INTT Schedule Update

Mesh Ground Design

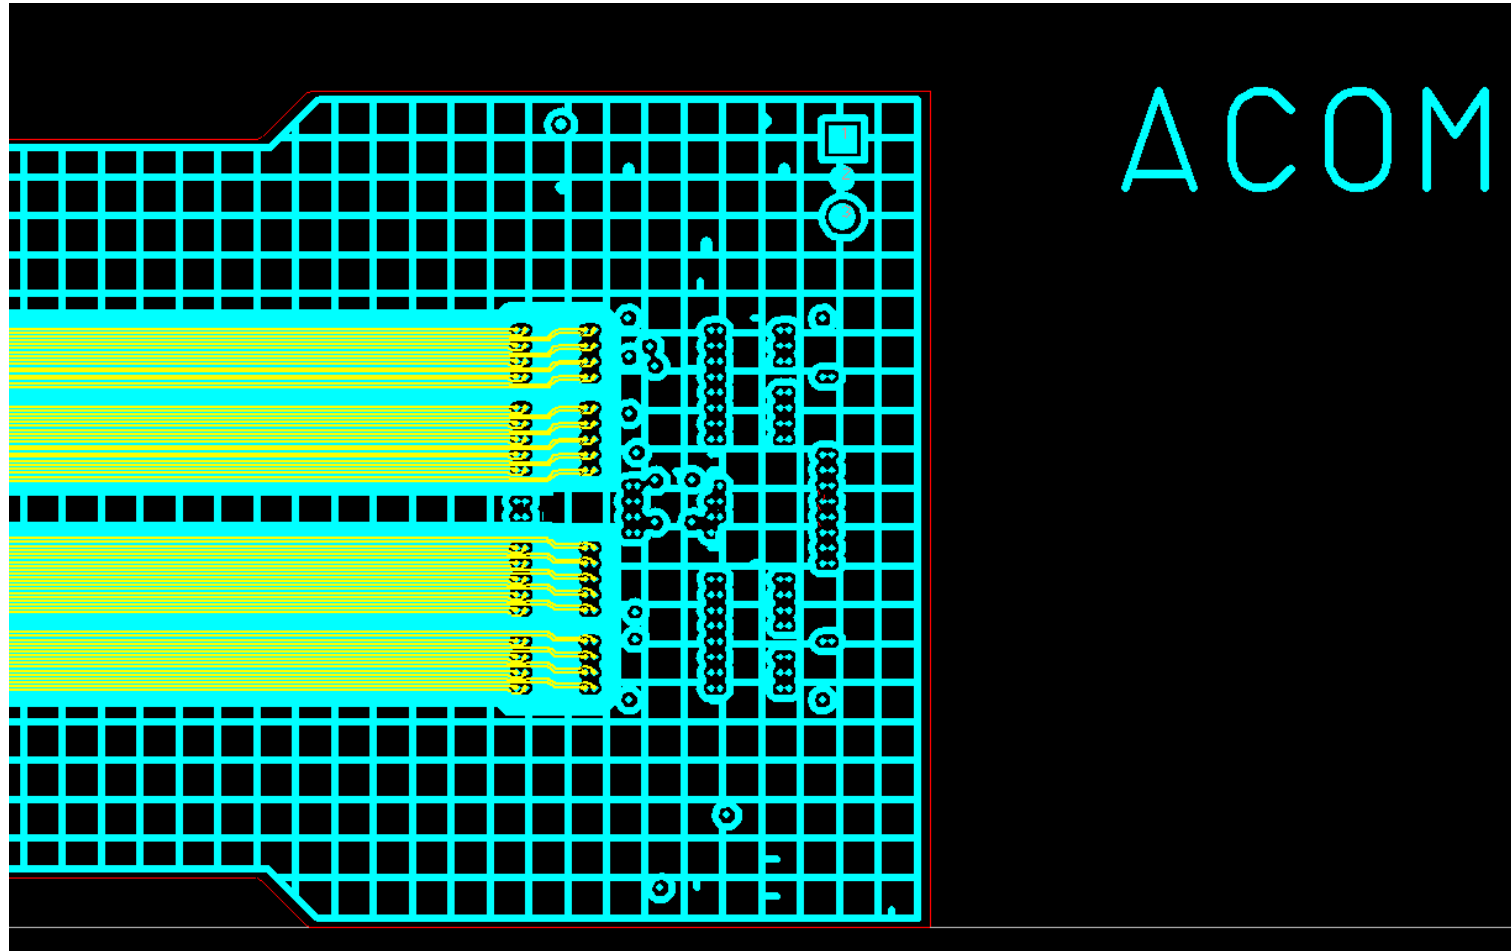
Worry about mesh

I'm not an expert on this. Our problem was not layer-to-layer noise, but the noise in the environment getting into the cables and completely overwhelming the signal from the silicon.

Perhaps it is time to do a test with a mesh to see how deep signals penetrate through a give mesh size (which could be big for the test)?

Why don't you just do a thin, solid shield plane?

Frankly, I don't have a feeling how the mesh design let noise to penetrate in depth. Do you know if there is a good reference about this? I guess the noise effect generated in the signal layer to the other layers can be simulated by a simulator. However, we won't be able to simulate the noise effect comes from external source since we don't know the its distribution...

We need circuit simulation work on this. Any volunteer?
